City of Fredericksburg

Historic Review Board Meeting Agenda
Tuesday, June 13, 2023 ~ 5:30 PM
Law Enforcement Center
1601 E. Main Street
Fredericksburg, Texas 78624

HISTORIC REVIEW BOARD AGENDA MEMO

CAPTION: Application 23-133 at **505 W Schubert** - Evelyn Williams - new ADU

SHEET:
A-5

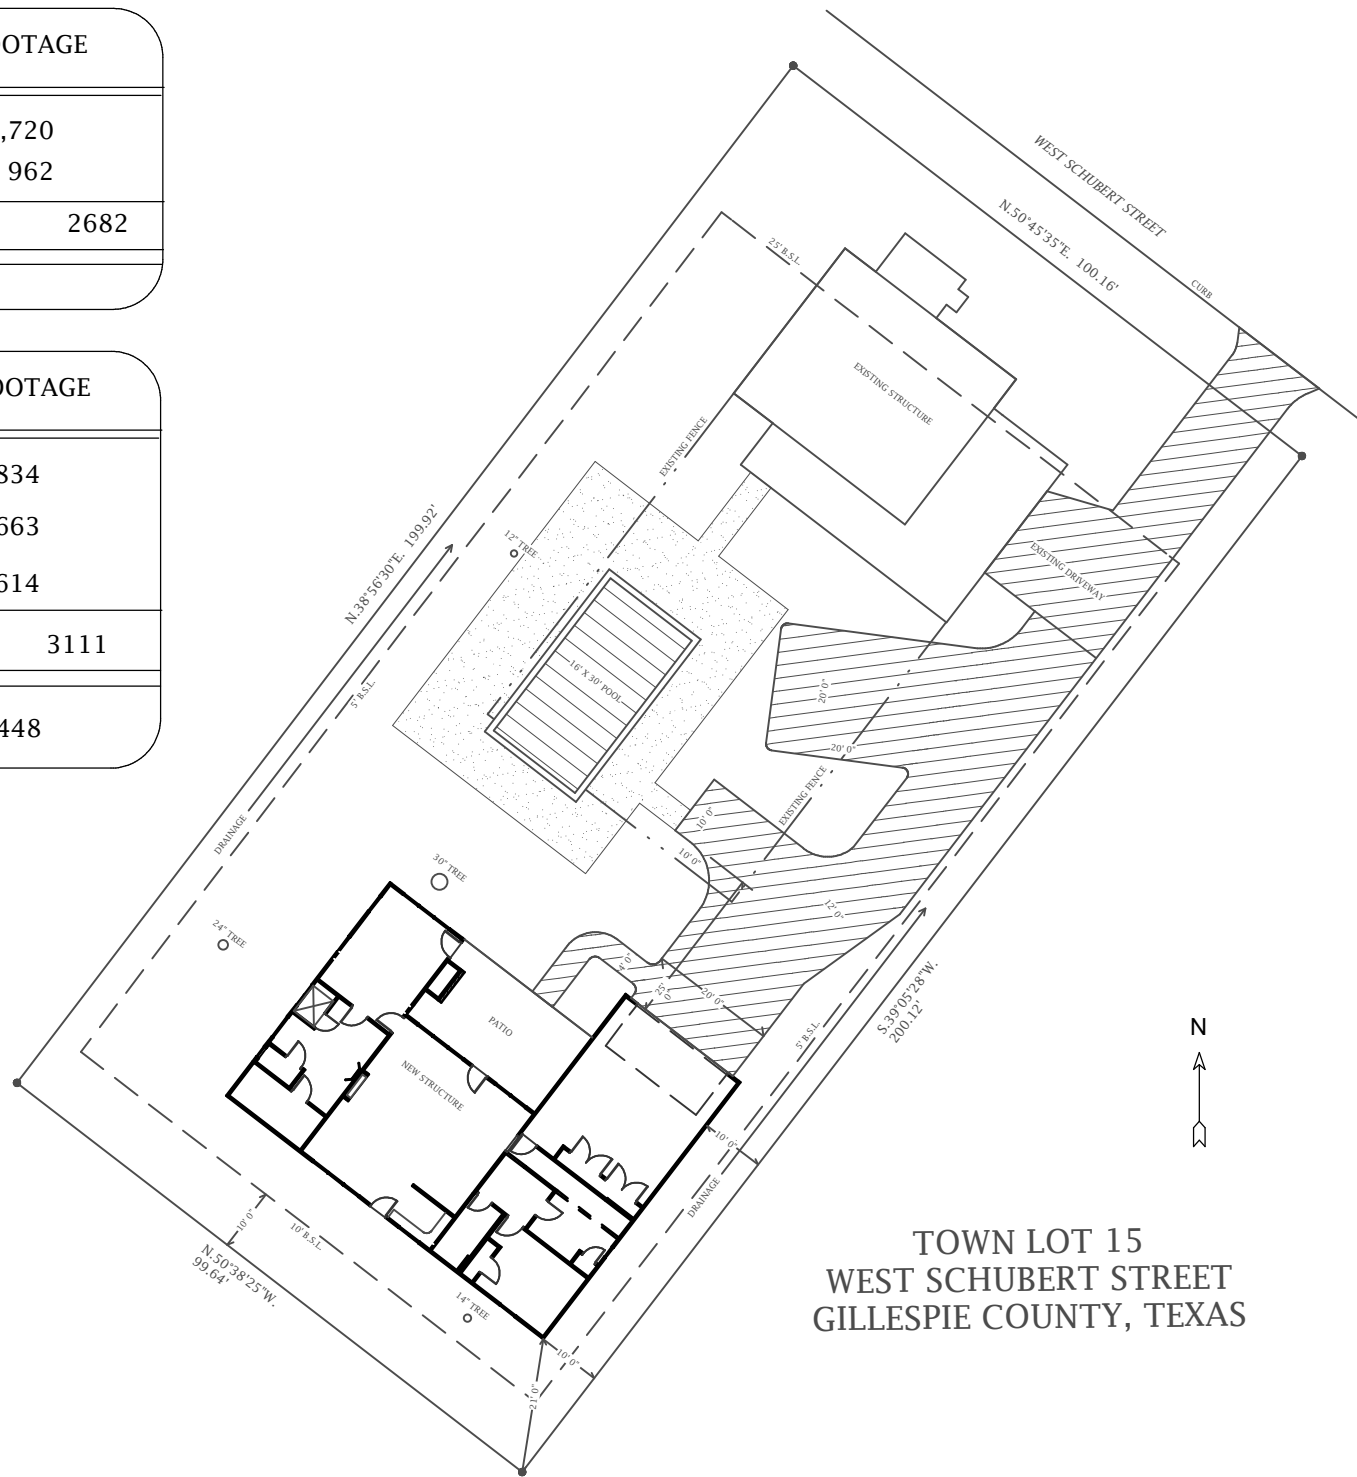
David Bullion commented on the size of the structure. He stated that the footprint of the existing house is 1,720 sq ft. The proposed ADU is 2,223 sq ft, which is larger than the main residence, which is not allowed by the design guidelines.

The Board discussed making modifications to the structure to make it smaller. The unit is 450 sq ft to large.

The applicant brought the original design to the HRB on May 9, 2023. The footprint was deemed to exceed the allowance per design guidelines. The new design has removed all covered porches (as recommended by the HRB) and storage has been added over the garage.

Richard Laughlin made a Motion to Approve Application #23-133 based on an exception due to size of the lot and location of buildings, conditioned upon removal of the side porch to the west, relocate the Master door to the Patio, remove back porch, front porch shorten by 4 ft, add a trellis on the garage and a turned ridge cap. Seconded by Joe Salinas. Amy Slaughter and Sam Childers voted in opposition. All others voted in favor and the motion carried.

EAST ELEVATION

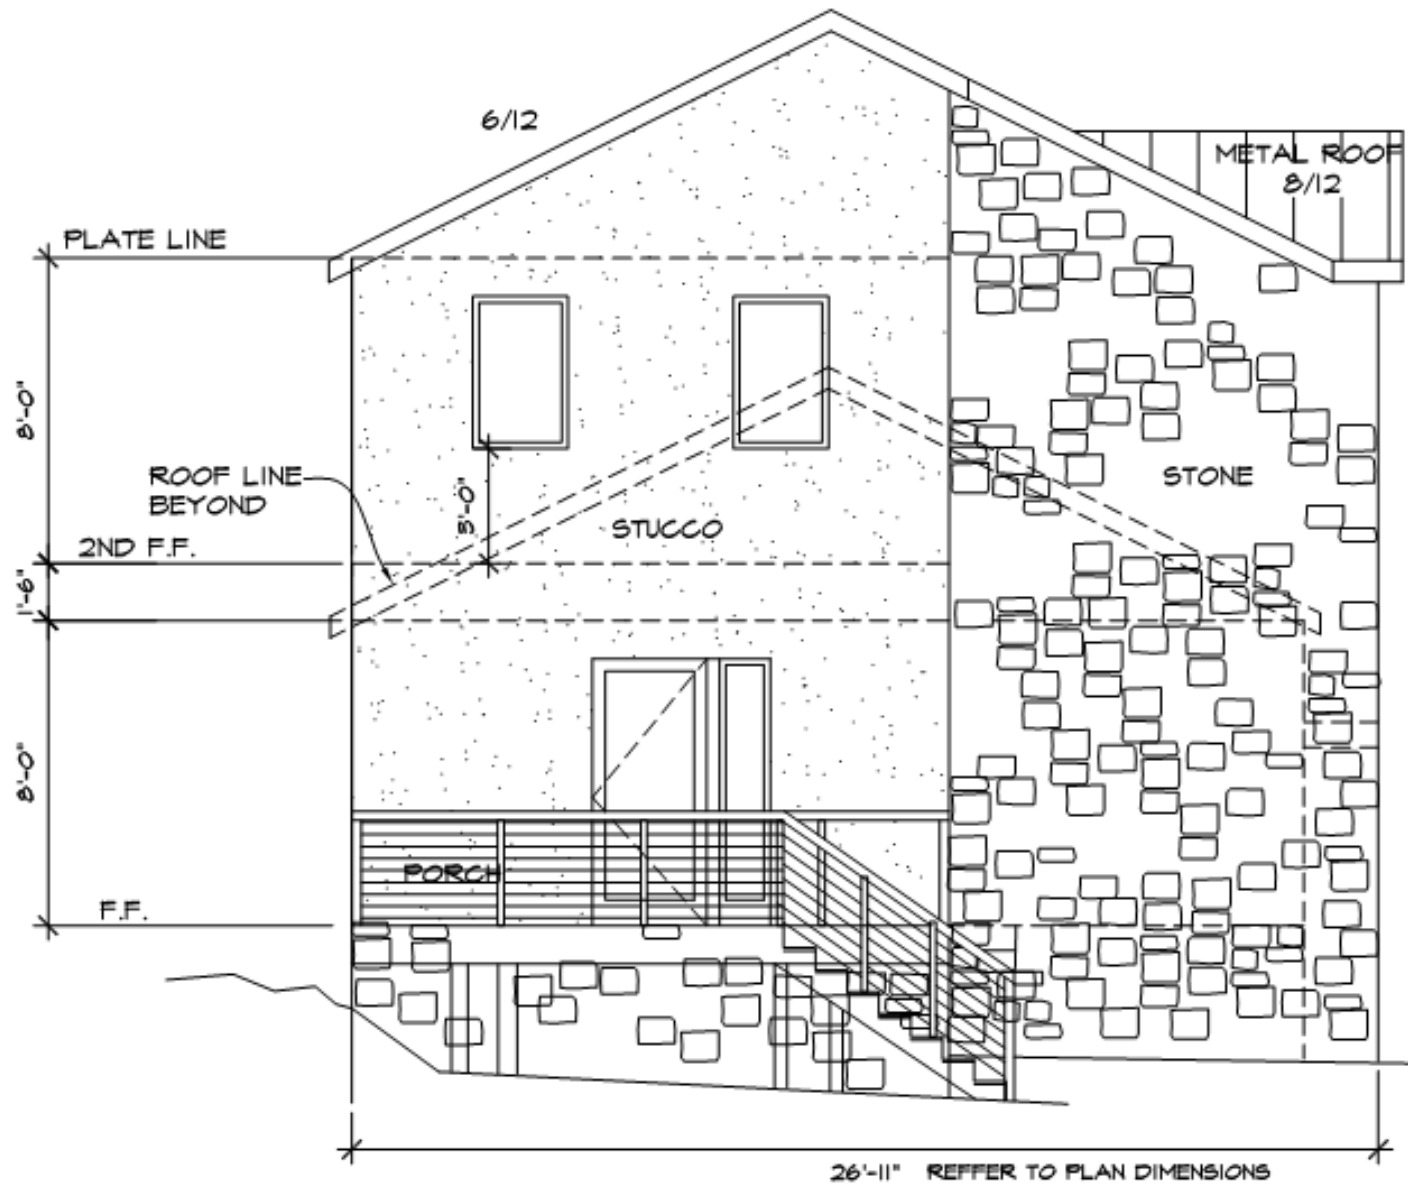
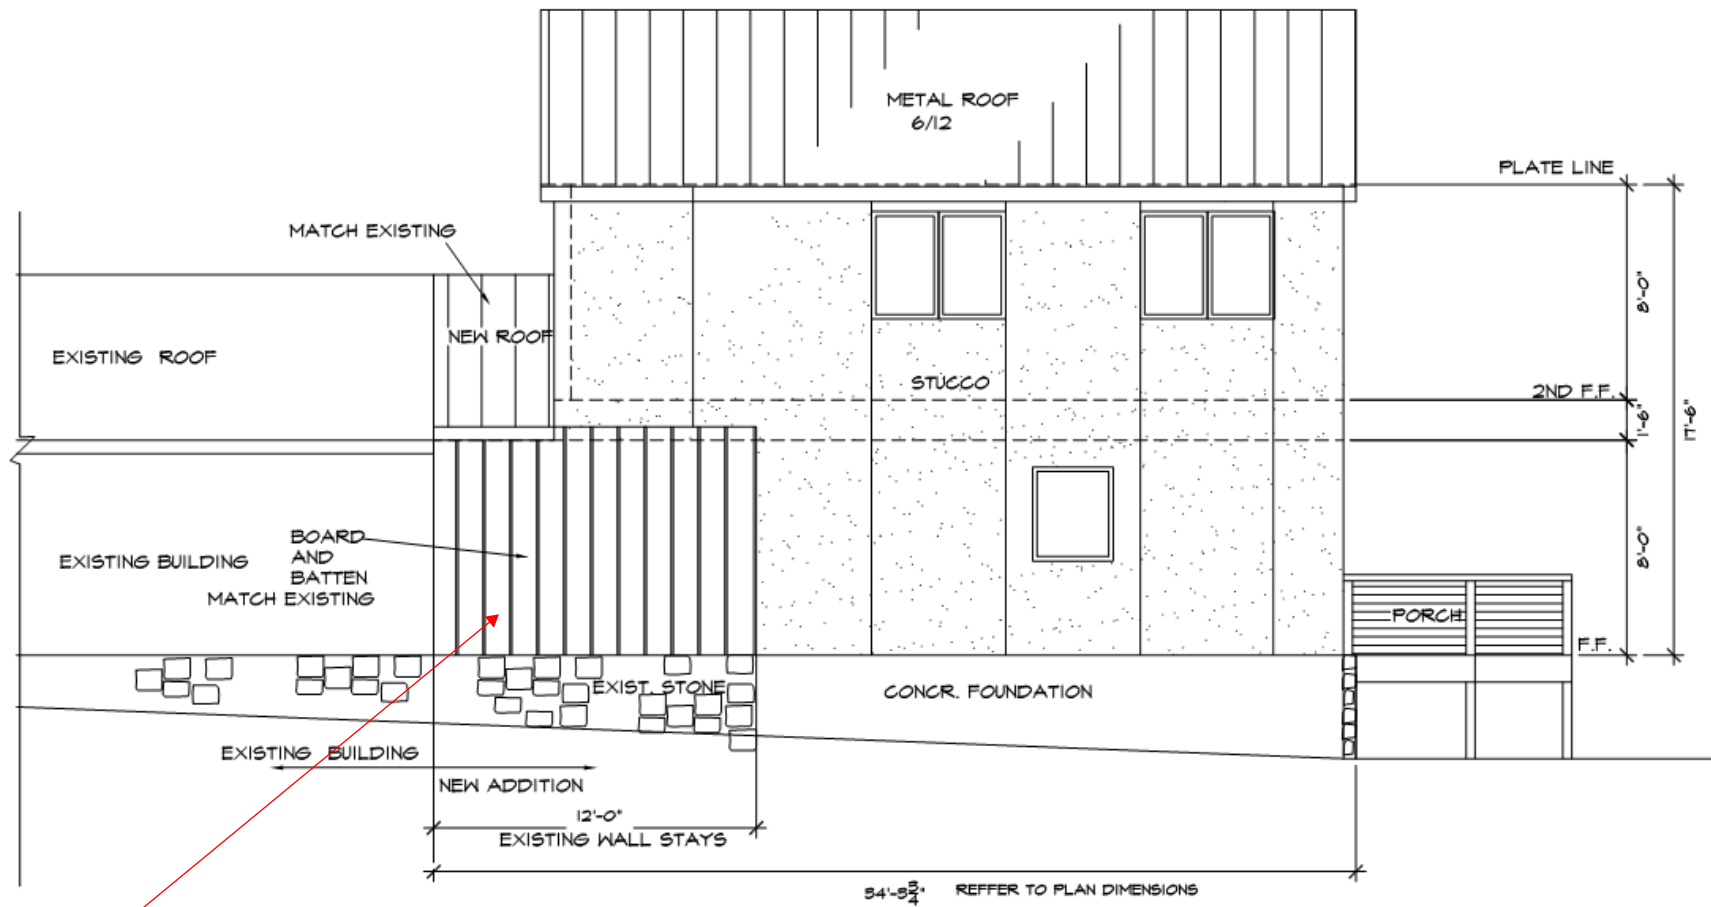
The proposed project adds approximately 1, 487 sq ft to the existing 1,927 sq ft. dental office connecting at an existing addition (not impacting original material) the medium rated resource as recommended per Sec. 3.3.d. The site has a substantial grade change from the front of the property facing north, to the back of the property facing south resulting in an increase in height for the addition from grade. However, the roof line is in keeping with the existing historical structure facing West Creek Street. The total height of the two-story addition is 16 feet from the porch to the plate line.

The design of the addition will incorporate stucco and stone and the use of the materials are done in such a way as to identify the addition as new as required per Sec. 3.3.I - *Design new additions to be compatible with the historic building but differentiated enough so that they are not confused as historic or original to the building.* The new addition should not overpower the existing main structure and should be visibly cohesive as a unit.

Staff recommends approval the addition as it will connect to an earlier addition and will not impact any historic material. It is sufficiently compatible with the historic design yet clearly modern. The removal of the faux fachwerk trim on the existing addition that remains is appropriate. The two-story section of the addition is adequately spaced from the 1.5 story historic Sunday house.

FRONT (EAST) ELEVATION

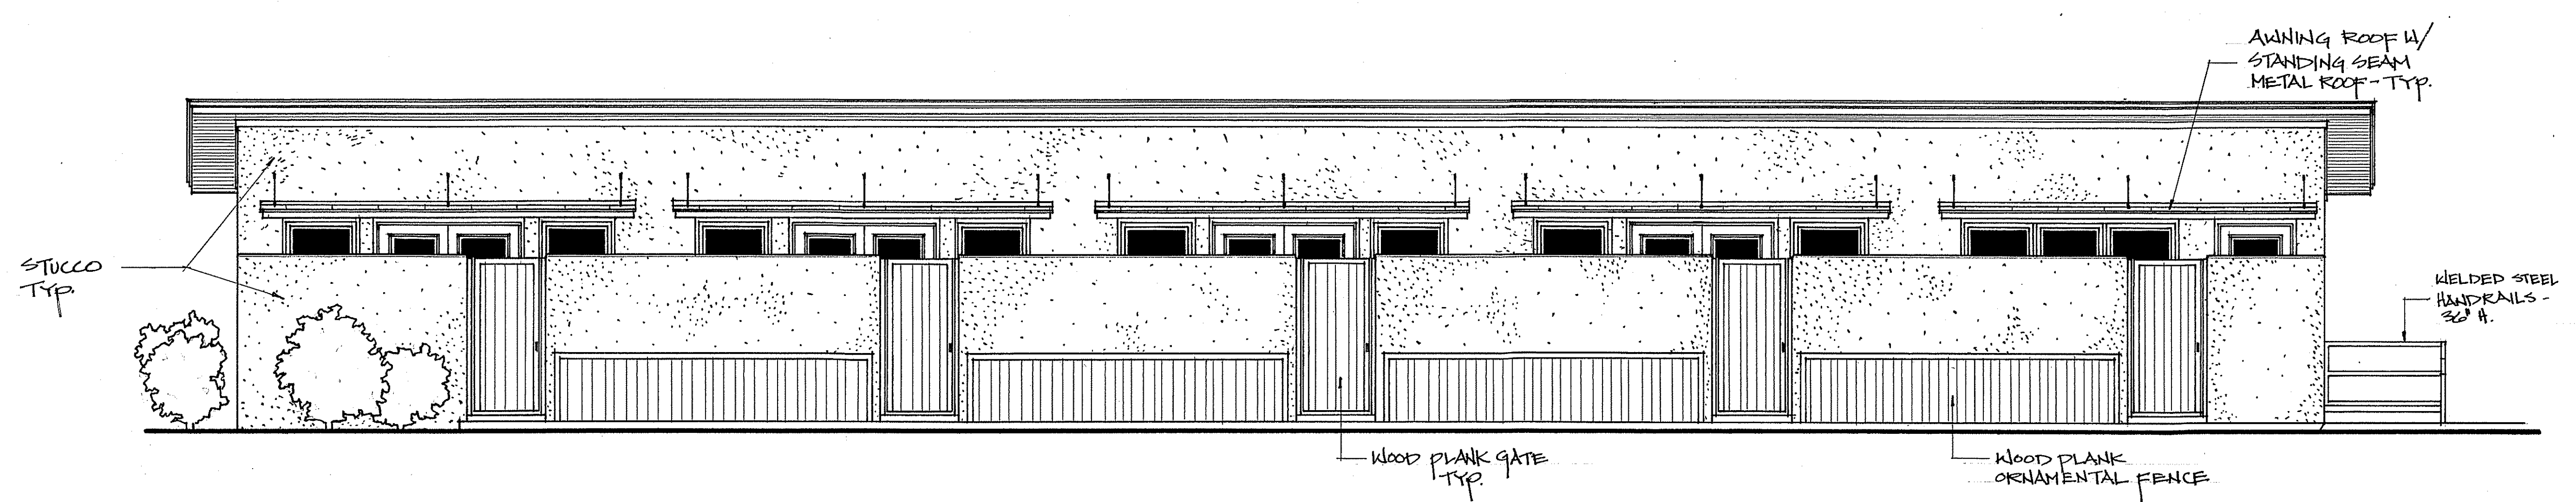
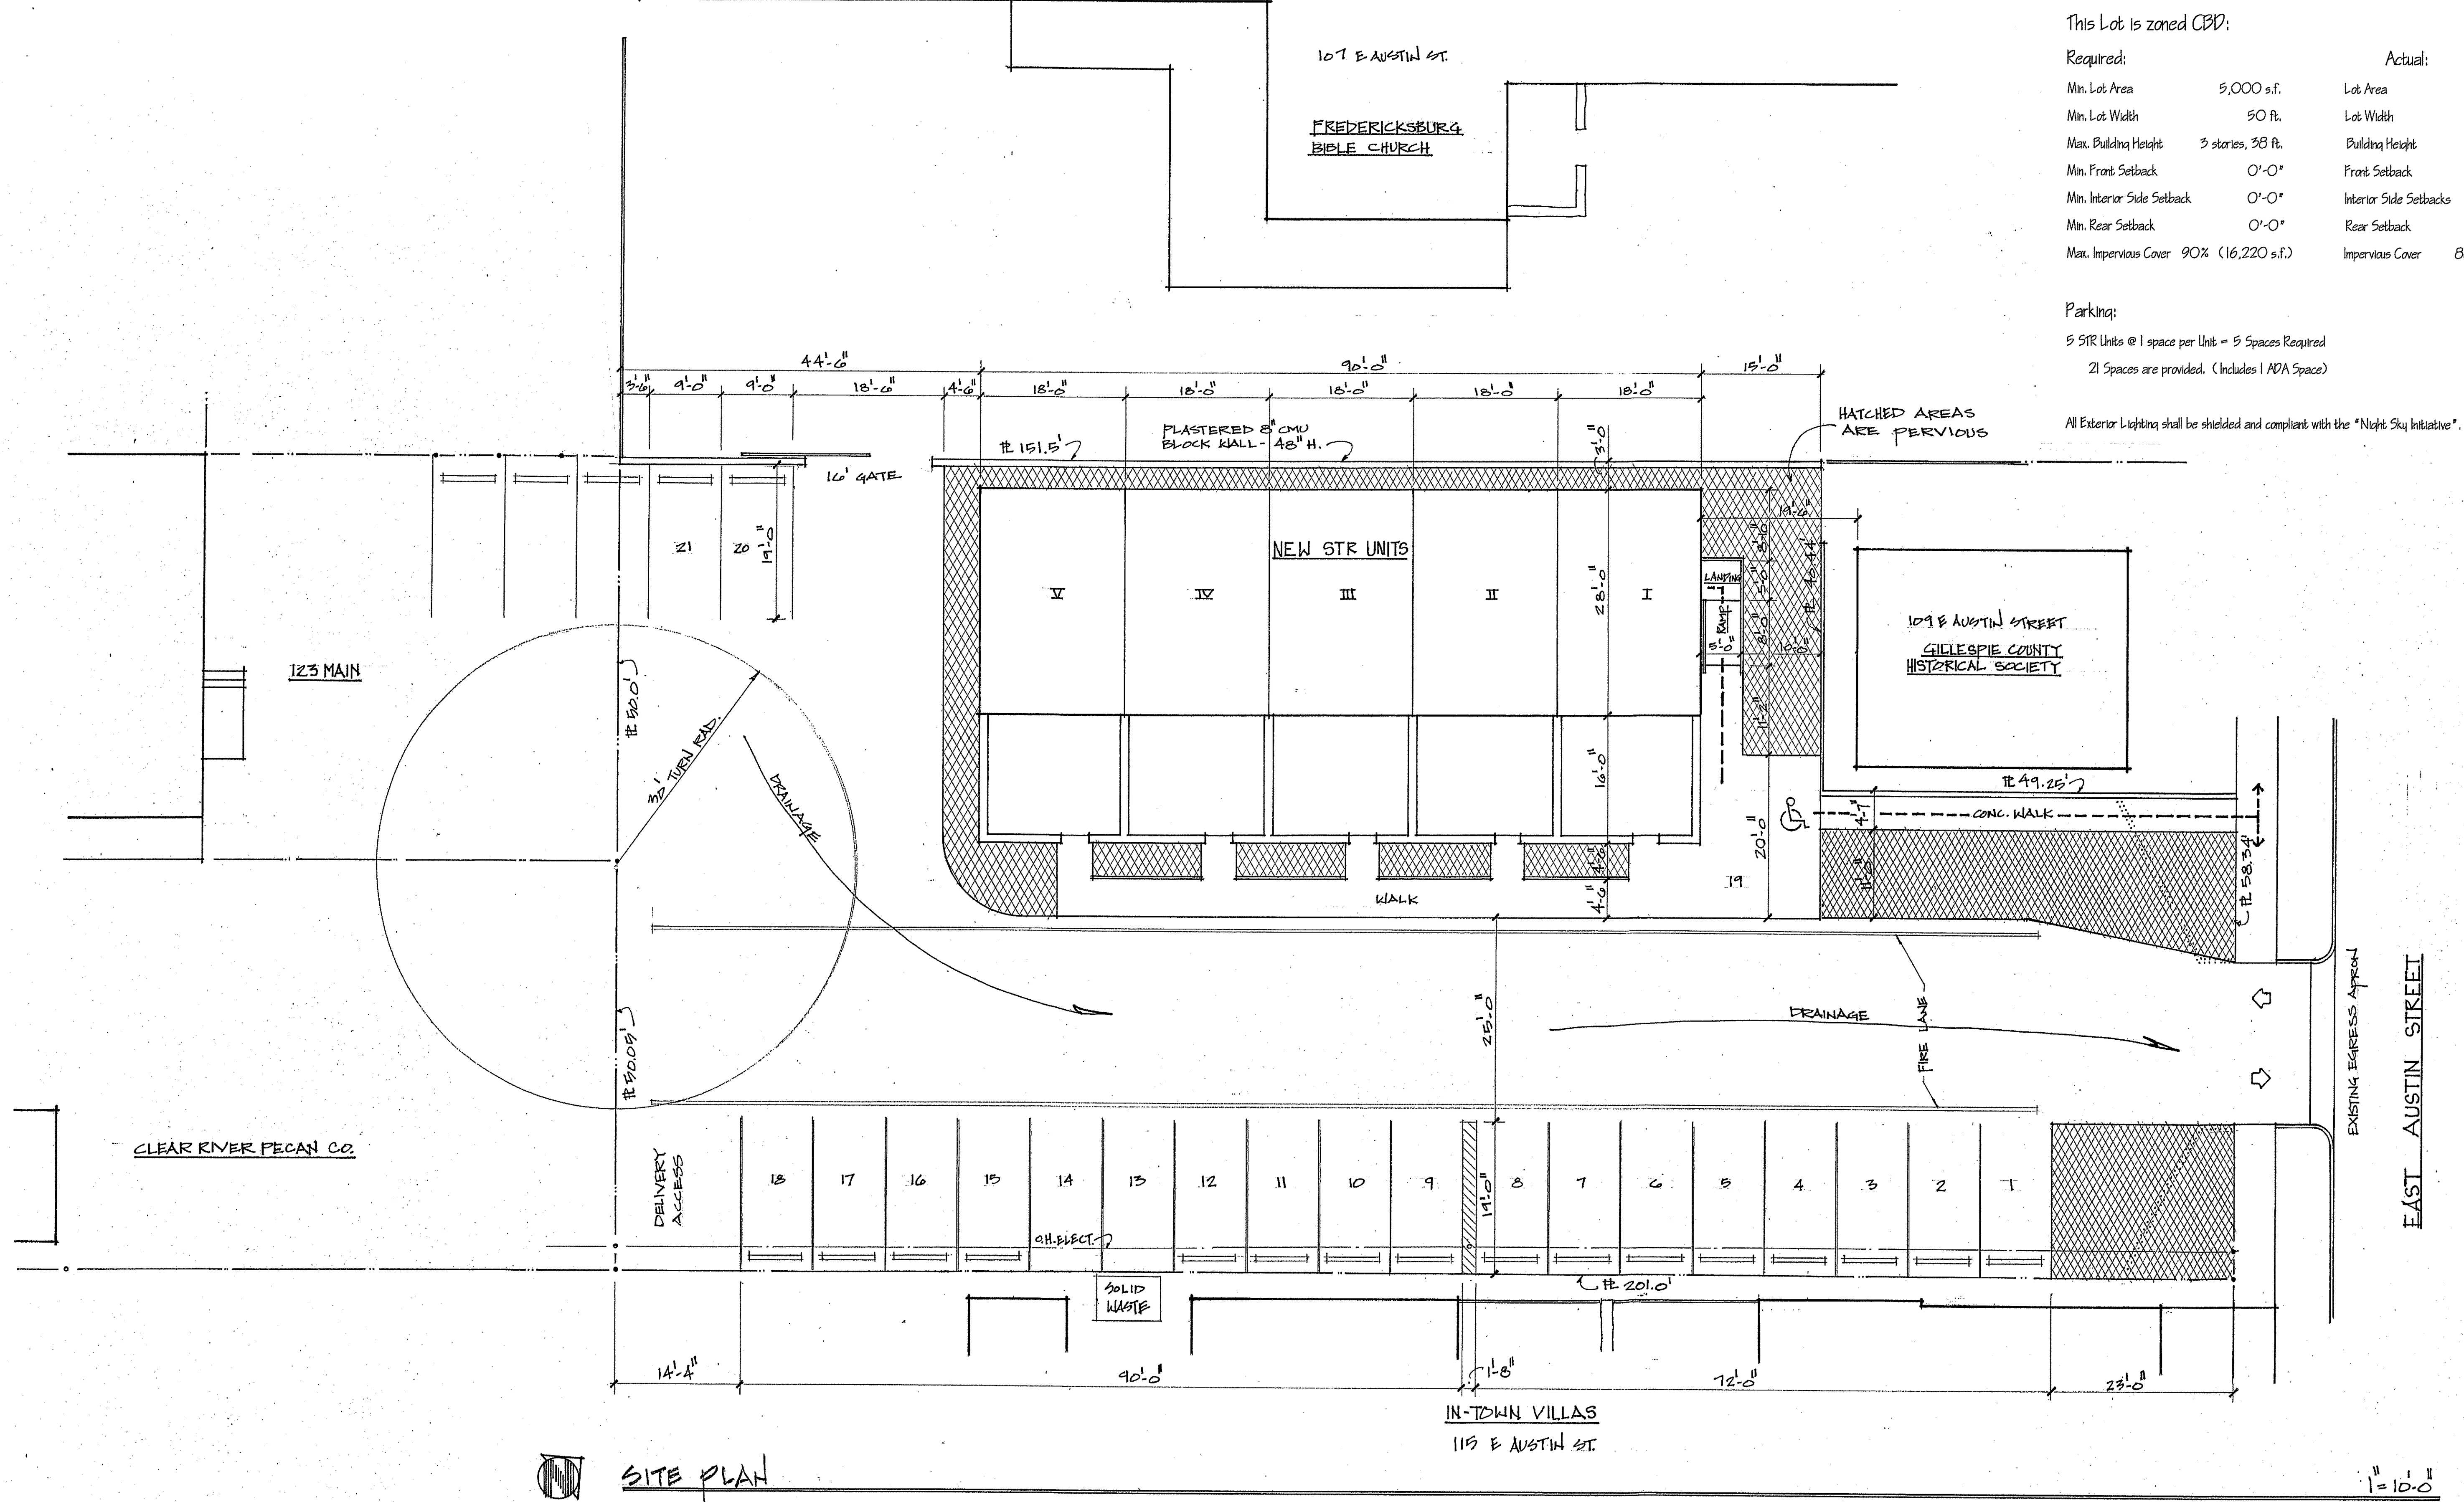
The proposed development adds approximately 4,000 sq ft of building coverage to an existing paved parking lot. The proposal does not remove historical resources and is in line with the base zoning requirements. In addition, the new development is 19.6 feet from the High rated property located at

As the development is adding to an existing parking lot, there is ample parking to accommodate the project. However, Staff recommends using landscape to soften the visual impact of the large parking lot per Sec. 3.4.1.K - *Always use landscaping as a buffer between service areas/parking lots and streets or buildings, as well as to break up the visual effect of a parking lot – regardless of the location of the service area or parking lot.*

Given the shape of the existing lot and its location behind the historic property located at 109 E. Austin, the project is unable to orient the structures facing the street as is required per Sec. 3.4.2.2. Rather, the proposal is to have the structures facing east, which allows the project to take advantage of the existing parking and provides an opportunity to highlight the pedestrian access to the units and neighboring commercial uses. The proposed height is in keeping with surrounding resources such as the historic church at 111 E. Austin.

The proposed new construction is in keeping with the Design Guidelines and is harmonious with existing developments on the neighboring site (142 East Main - The Villas). Staff recommends approval.
